Technical Service Bulletin

21 Mil on - P0299 Negative pressure deviation, turbocharger excessive wastegate play

21 13 12 2031245/3 April 1, 2013. Supersedes Technical Service Bulletin Group 21 number 13-11 dated March 6, 2013 for reasons listed below.

Figure 1. Fit the clip from the side.

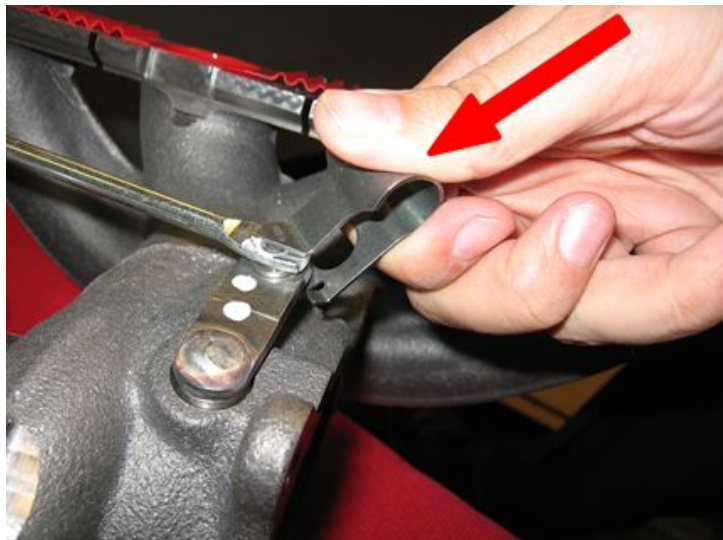
1. Remove turbocharger as per ELSA instructions: *Repair Manual >> Engine / Engine Mechanical >> 21 Turbocharger, G-Charger >> Removal and Installation >> Turbocharger.*
2. Install clip **06J145220B** on a replacement turbocharger's link plate and actuating rod joint as illustrated (Figures 1 and 2).

Figure 3. (1) Maximum opening of clip, (2) Position of original circlip

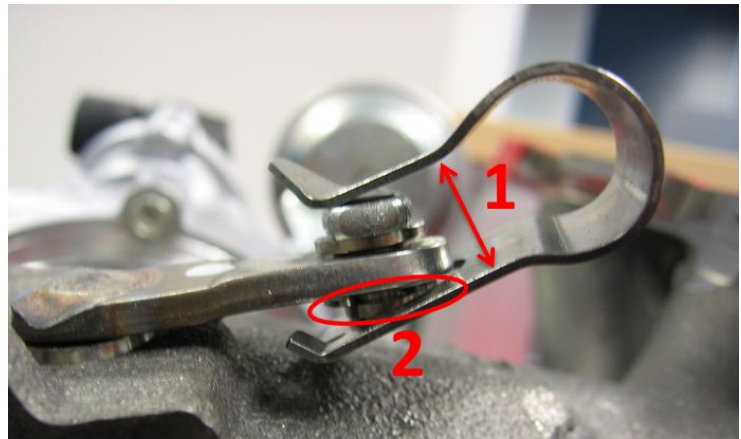
- The spring clip must not be overstretched. The maximum opening of the spring clip is 14 mm (Figure 3, 1).
- The spring clip must be replaced after every removal.

Figure 4. Correctly-fitted clip.

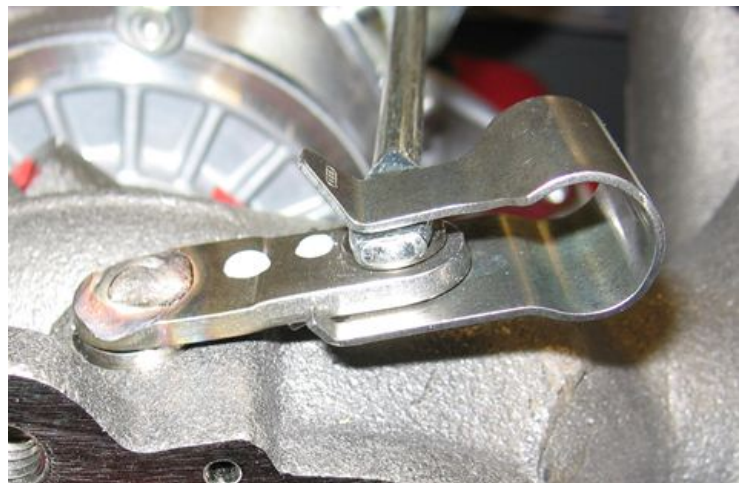
3. After fitting the spring clip, check for correct fit (Figure 4).

Figure 5. (1) Maximum opening of clip, (2) Position of original circlip

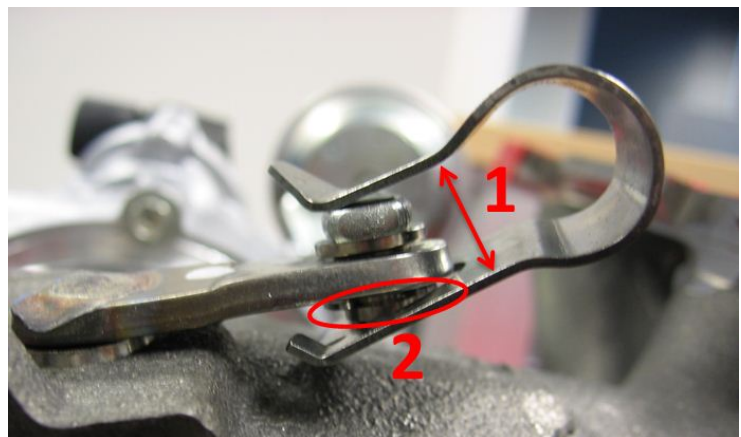
4. After fitting the spring clip, check the position of the original circlip (Figure 5, 2) and correct it if necessary.
